Change Order

PROJECT: (Name and address)
Raymond Community Park
Prosper, TX

CHANGE ORDER INFORMATION:
Change Order Number: 04
Date: October 15, 2025

The Scope of Work is modified as shown in the attached DCI PCR 042A dated 22 JUL 25 and
DCI PCR 046 dated 08 SEP 25.

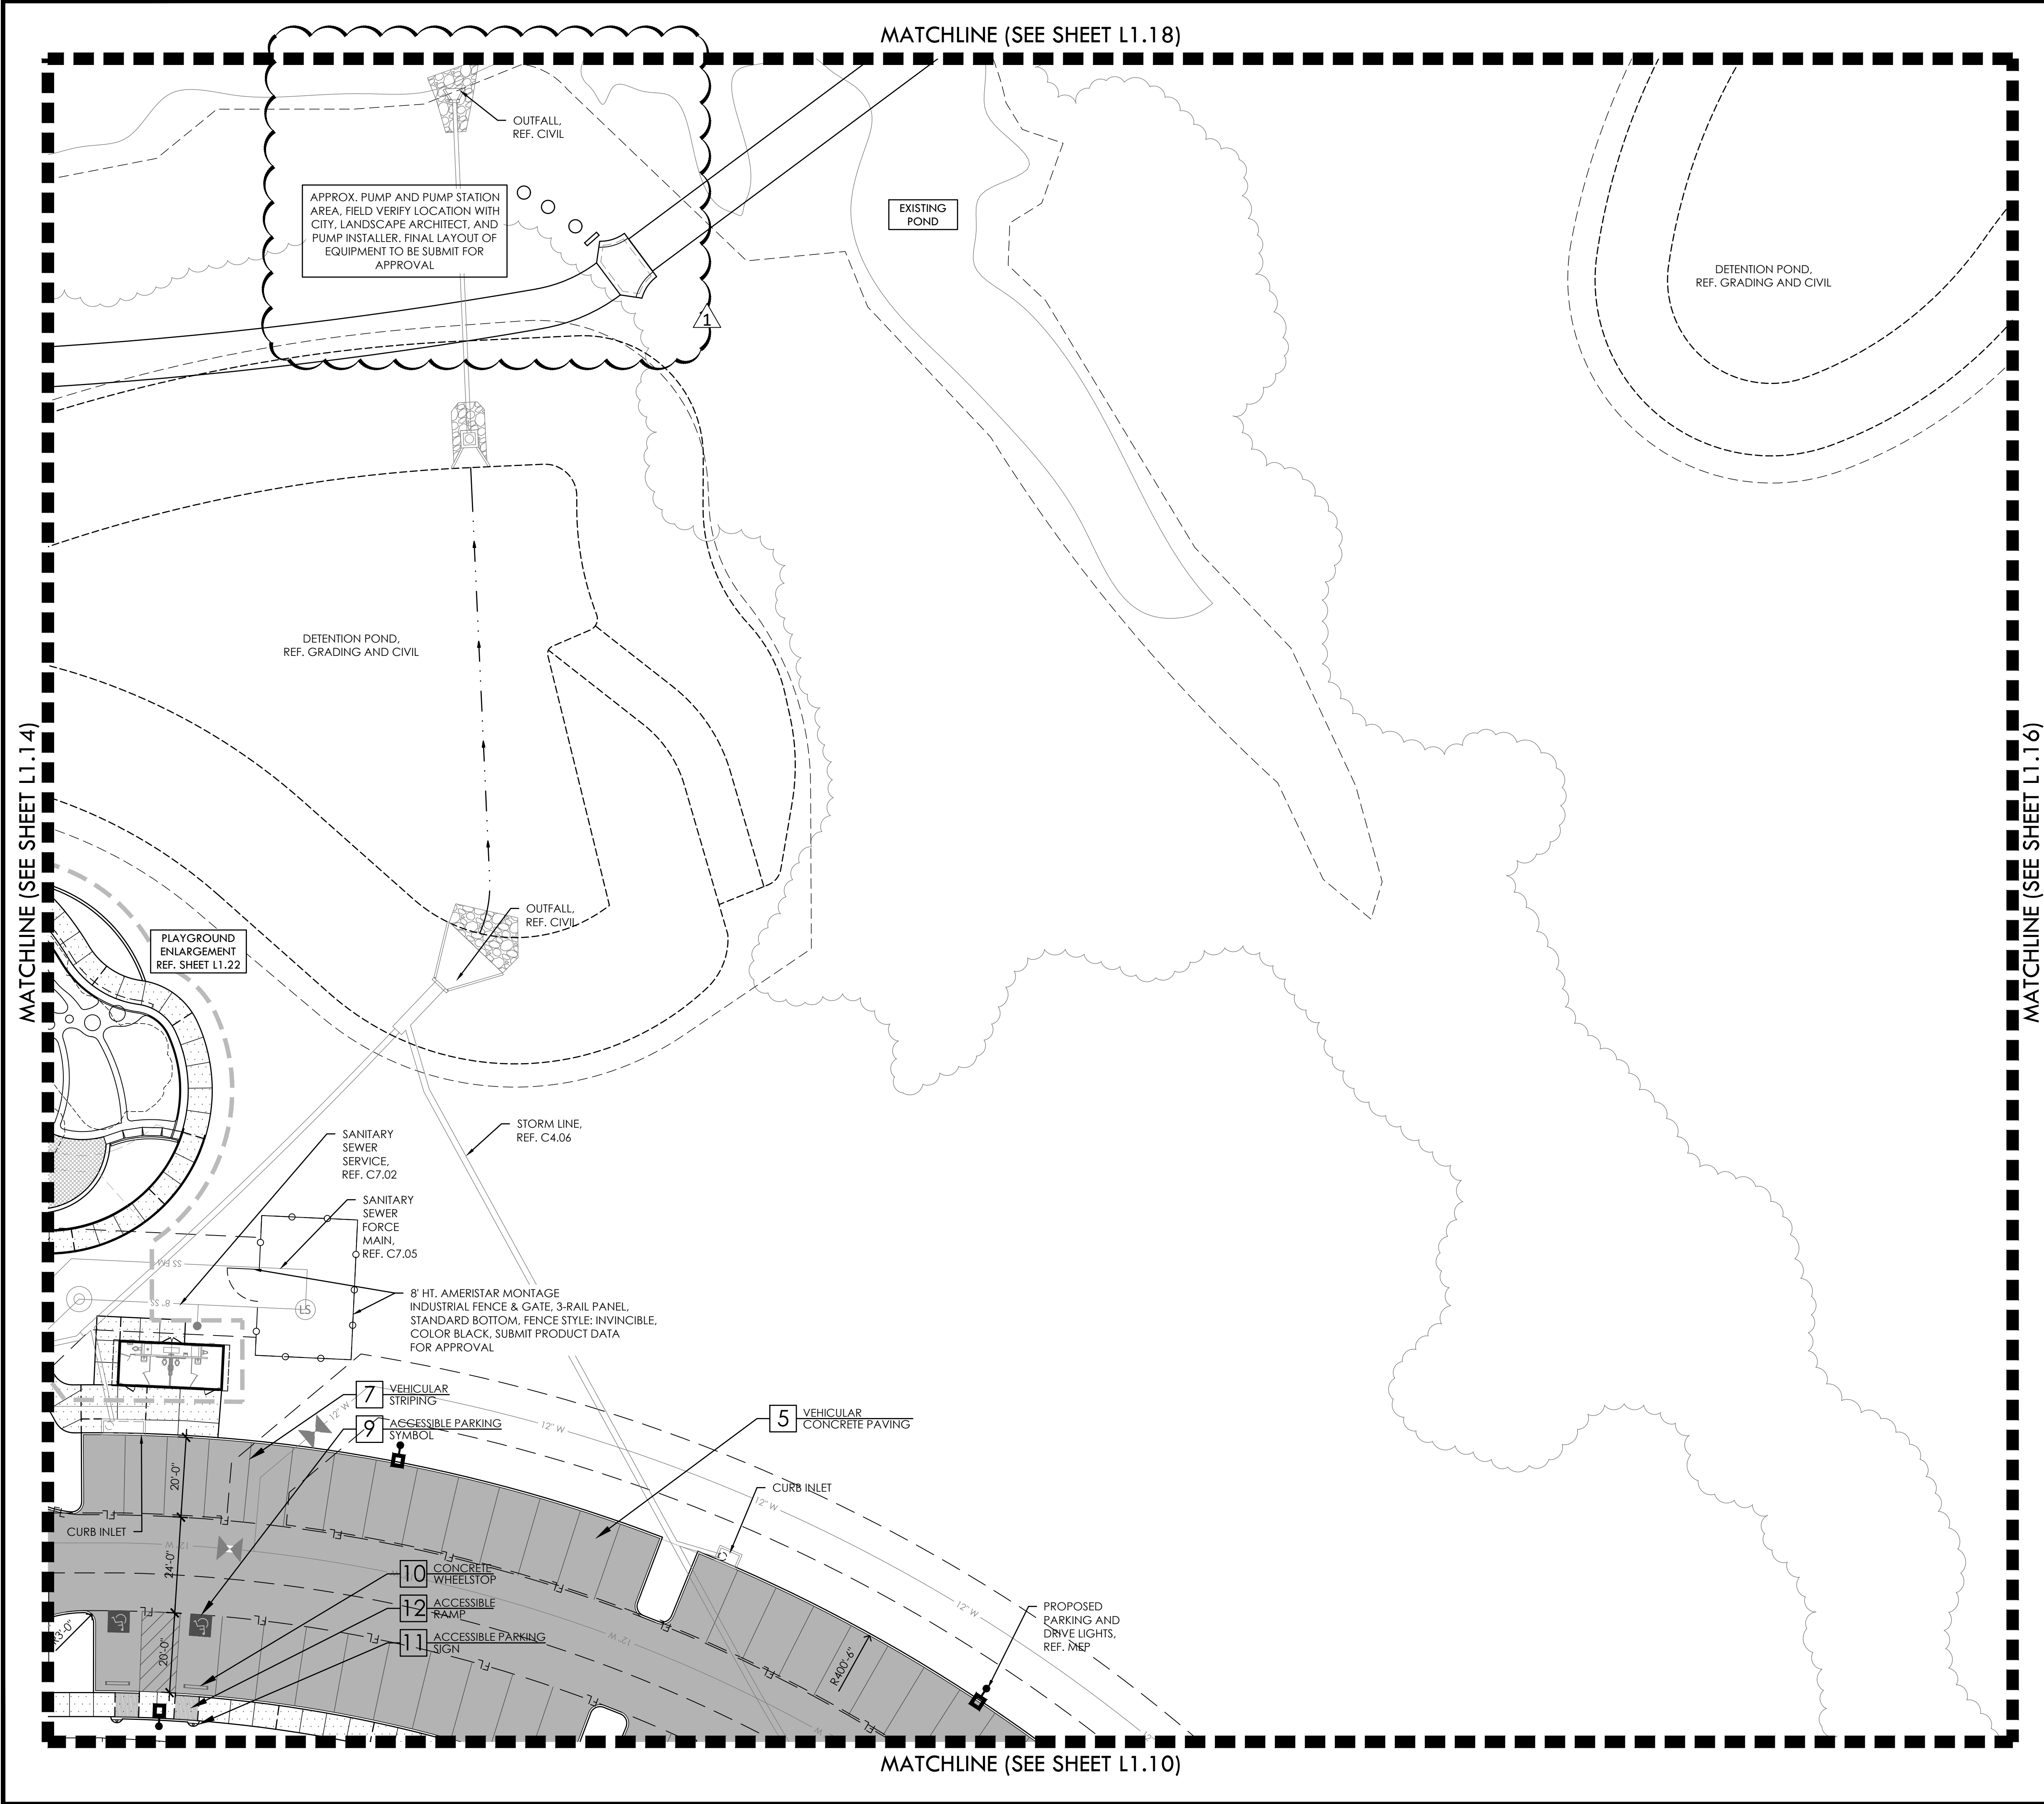
1. L5.00 – Overall Irrigation Plan
 - Irrigation Schedule updated
 - Pumps and mainline updates
2. L5.01 – Irrigation Plan – Area 1
 - Added note for disconnection of 4" meter

1. Pump mainline for south east irrigation, approx. additional 1,165 lf of 4" mainline.
2. Pump mainline for south west irrigation, approx. additional 1,237 lf of 4" mainline.
3. Pump mainline for remaining field & site irrigation, approx. additional 300 lf of 4" mainline
4. Pump mainline sleeve for south west irrigation approx. 61 lf for 4" mainline.
5. Removal of 4" mainline from north west side to old pump location, approx. reduction of 4" 576 of 4" mainline.

IRRIGATION PLAN - AREA 1

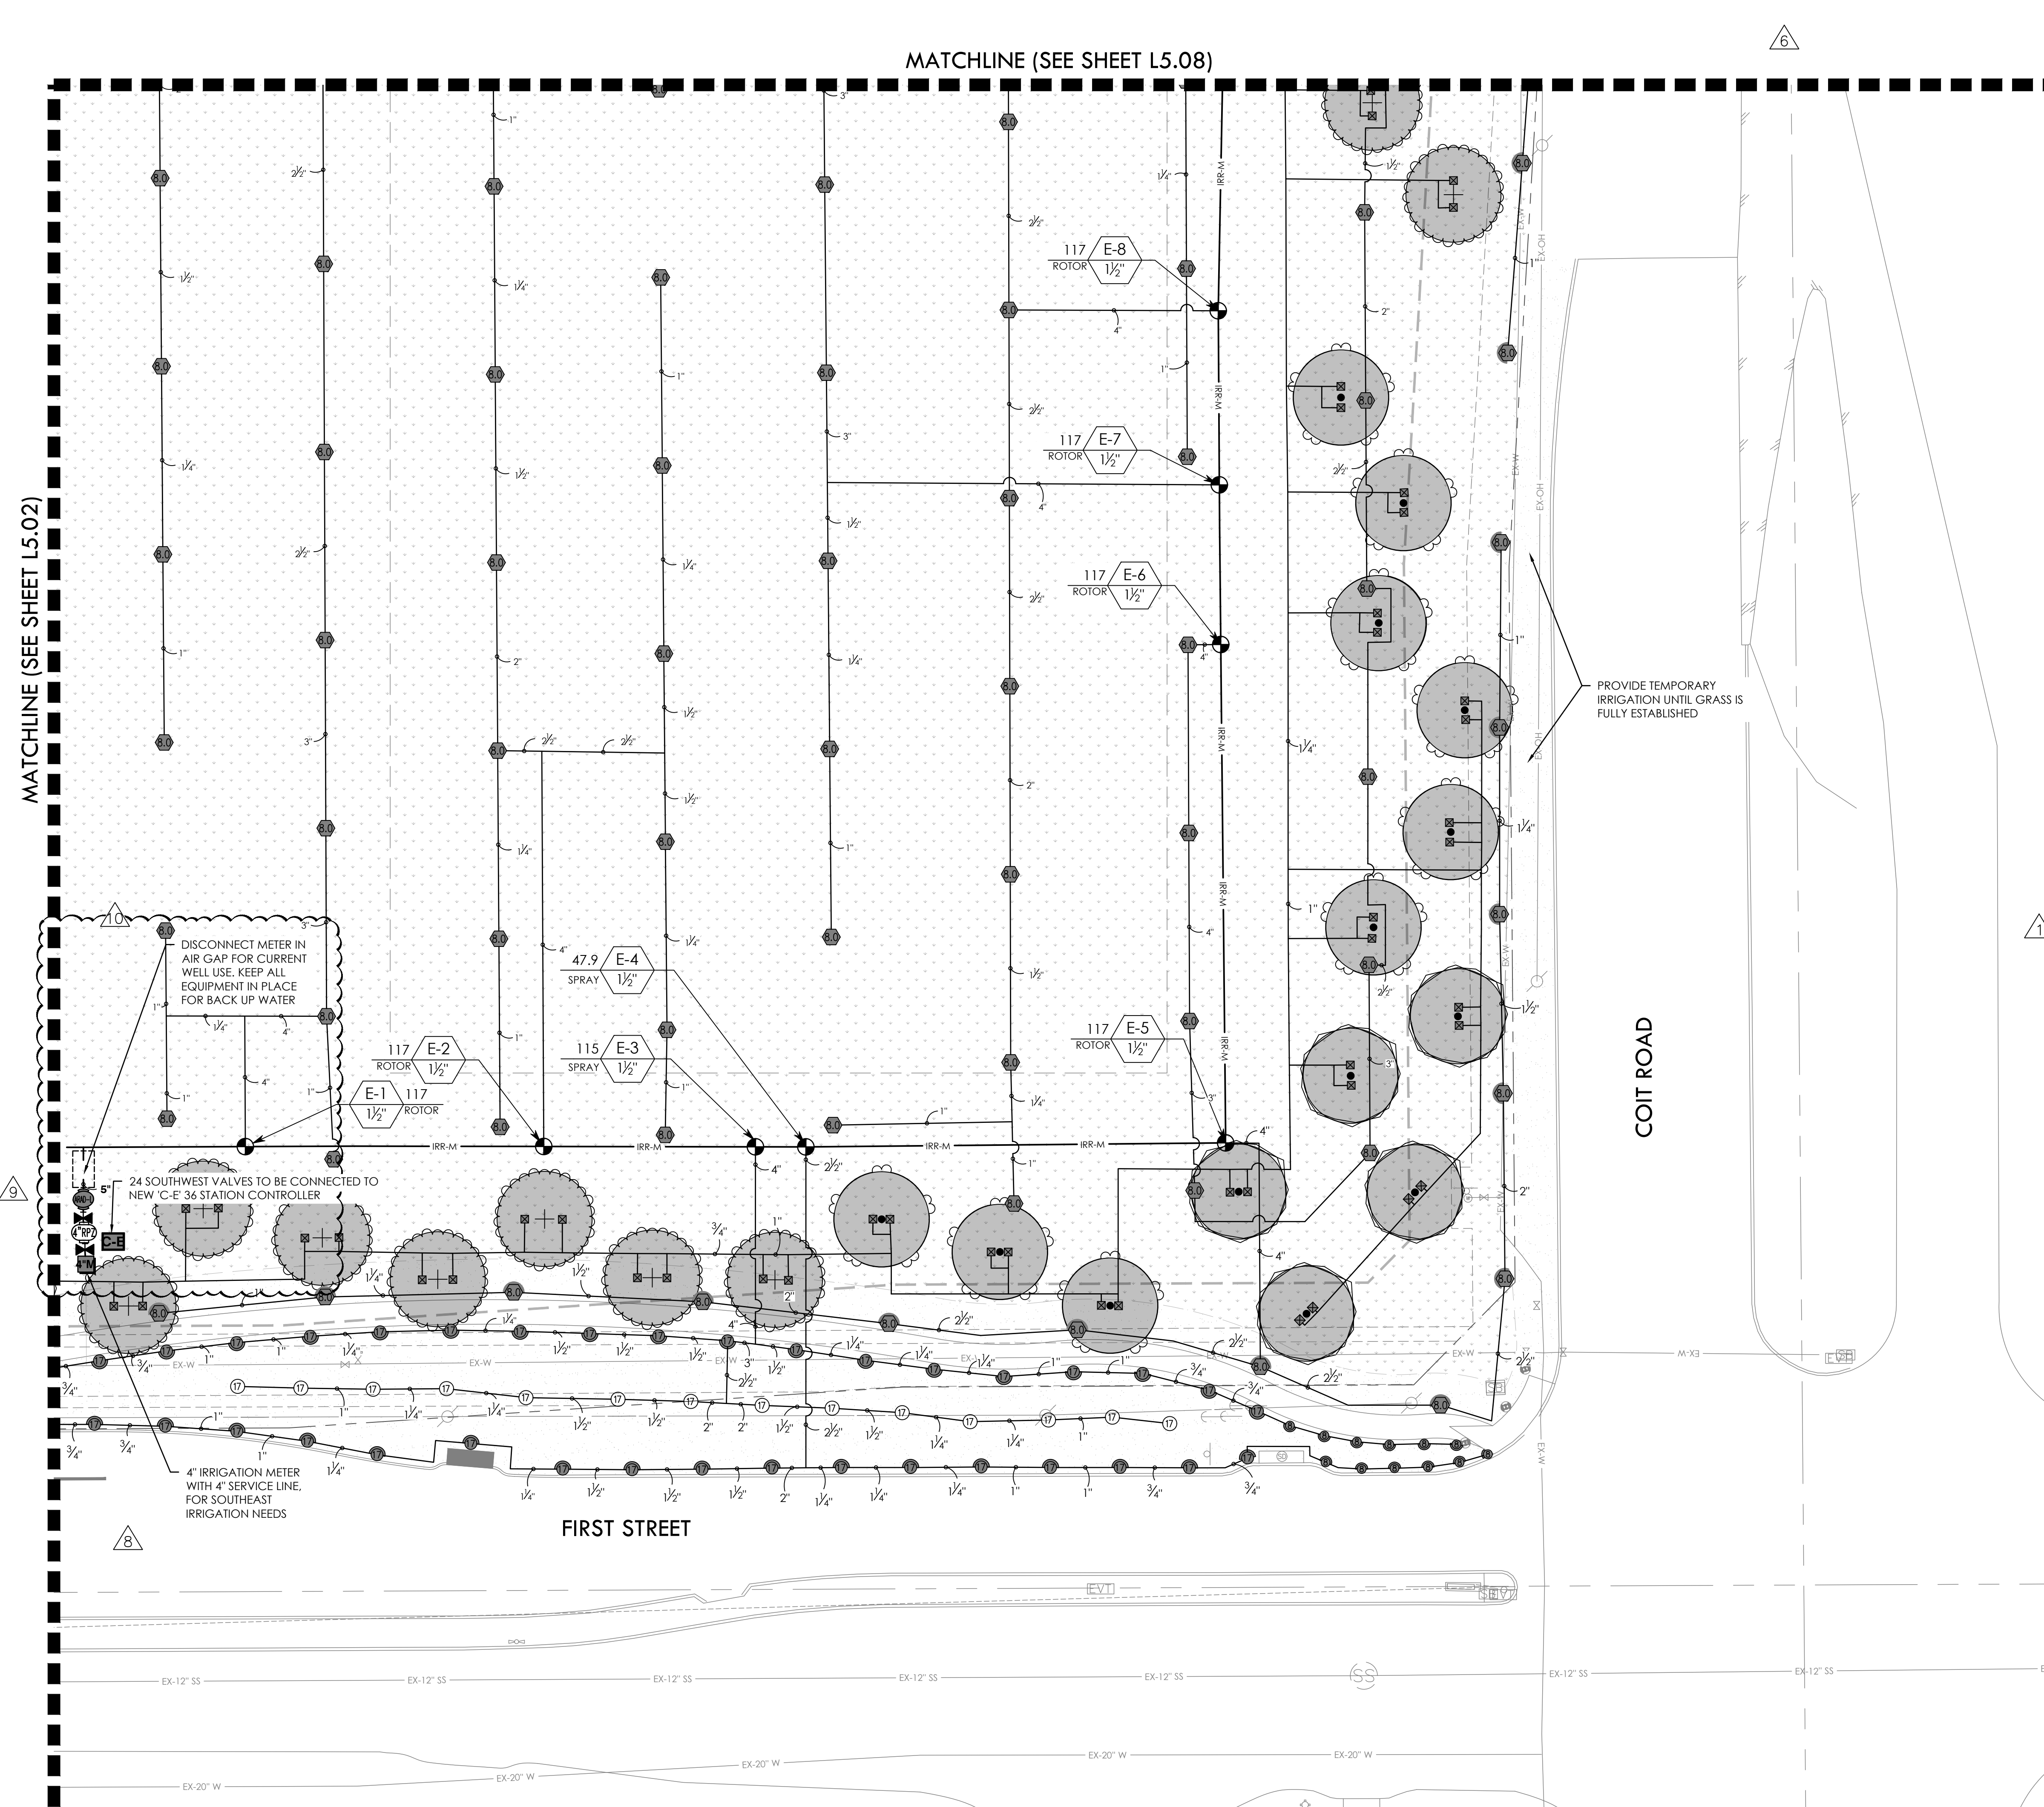
- Show mainline disconnect in air gap valve box
 - Lateral line connection from spray valve #3 to shrub bed valve #5. (RFI 063)
3. L5.02 – Irrigation Plan – Area 2

IRRIGATION PLAN - AREA 2

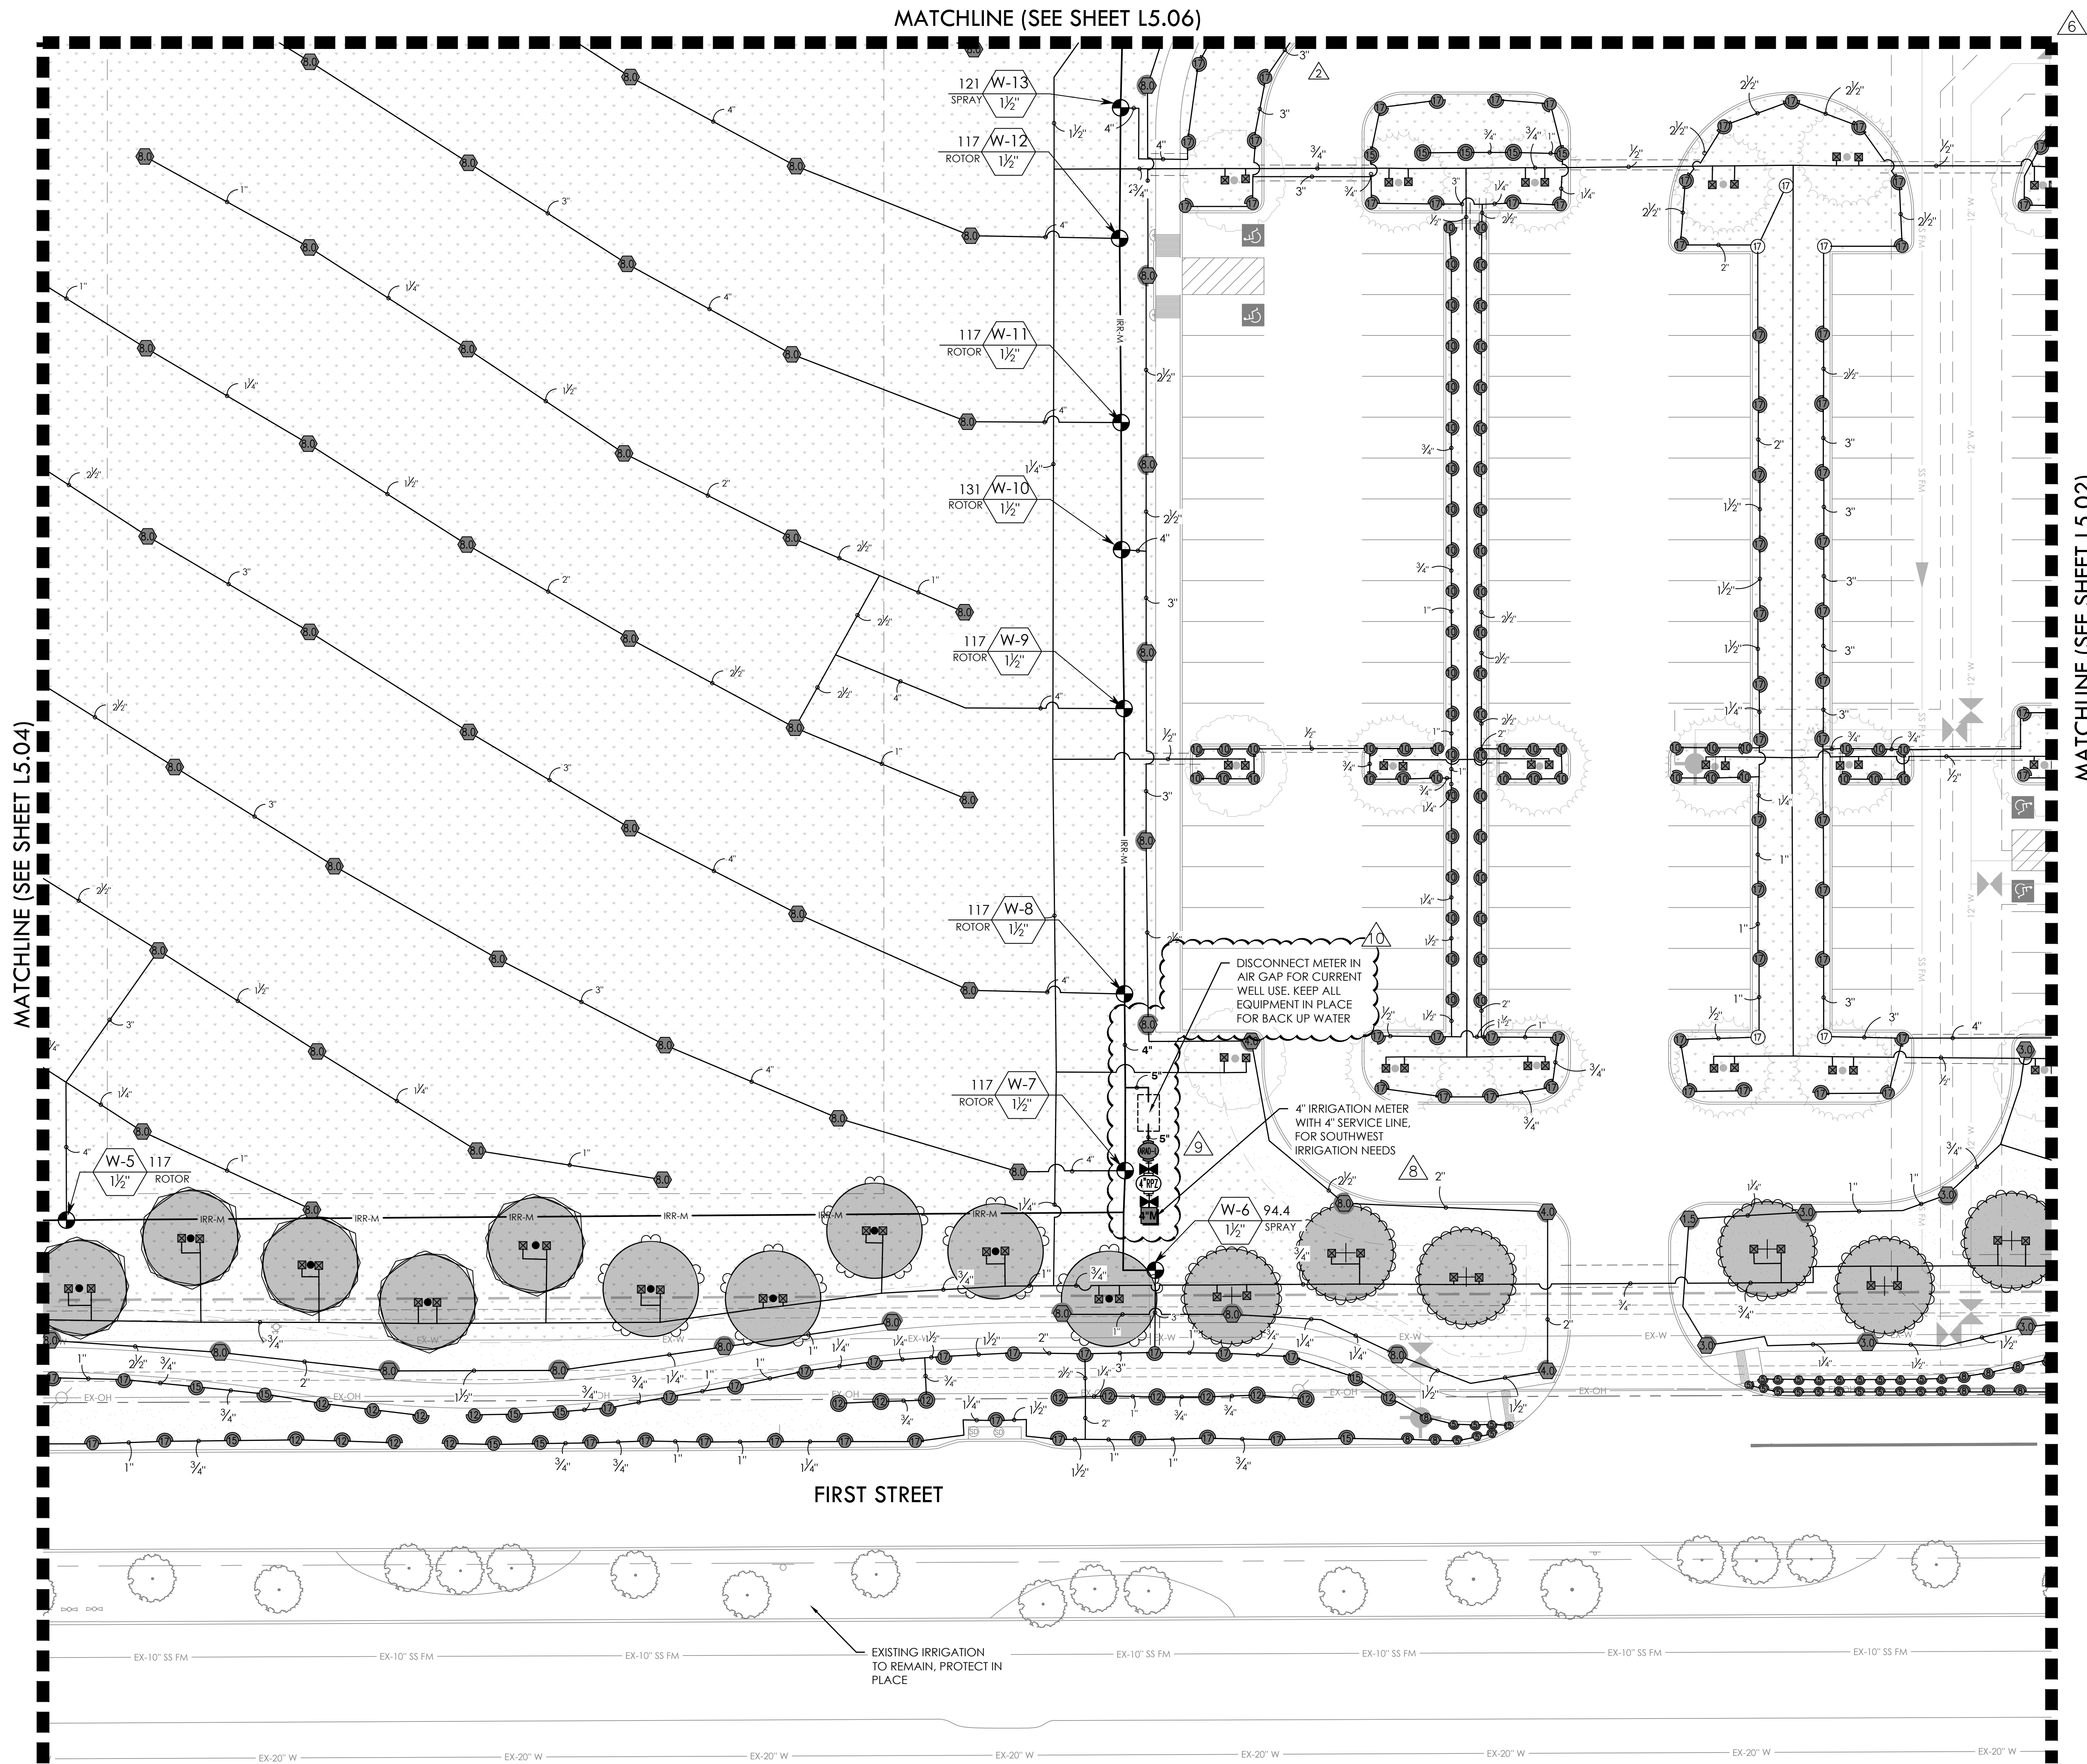
- Added note for disconnection of 4" meter
 - Show mainline disconnect in air gap valve box
4. L5.03 – Irrigation Plan – Area 3
 - Added note for disconnection of 4" meter
